PRODUCT/PROCESS CHANGE NOTICE (PCN)

PCN #: TB-0510-05 DATE: 14-Dec-2005 Product Affected: 48L, 56L, 64L TSSOP & 80L TVSOP & 48L, 56L TSSOP exposed pad (Green & Standard) Date Effective: 13-Jan-2006	MEANS OF DISTINGUISHING CHANGED DEVICES: <input type="checkbox"/> Product Mark <input type="checkbox"/> Back Mark <input type="checkbox"/> Date Code <input checked="" type="checkbox"/> Other Rev 07 printed on shipping tube
---	--

ATTACHMENT I - PCN #: TB-0510-05

PCN Type: Packing/Shipping

Existing Shipping Tube

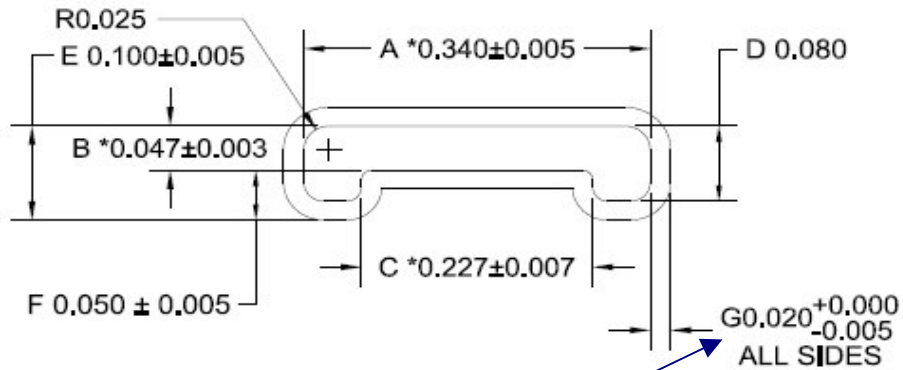
Existing Tube – wall thickness : 0.015 to 0.020

Existing Tube – printed revision, REV.06

New Shipping Tube

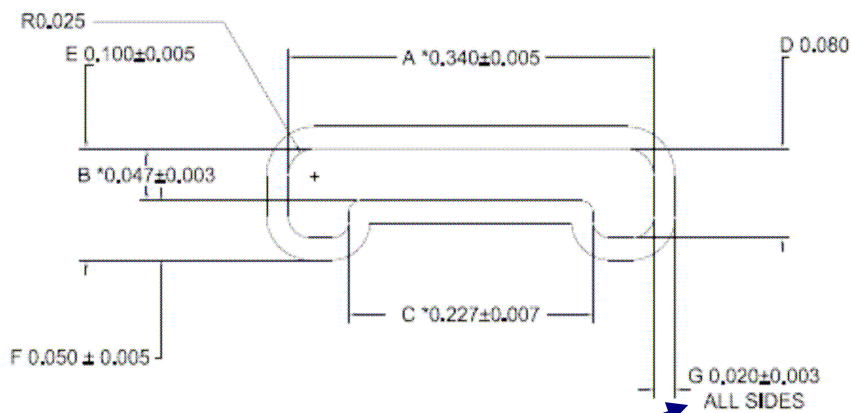
Detail of Change: This change is to increase the shipping tube's wall thickness in order to provide better protection to the packages during assembly, test and back-end processes. The changed shipping tube will be printed with Rev. 07 as shown in the detailed drawing.

New Tube – wall thickness : 0.017 to 0.023

New Tube – printed revision, REV.07
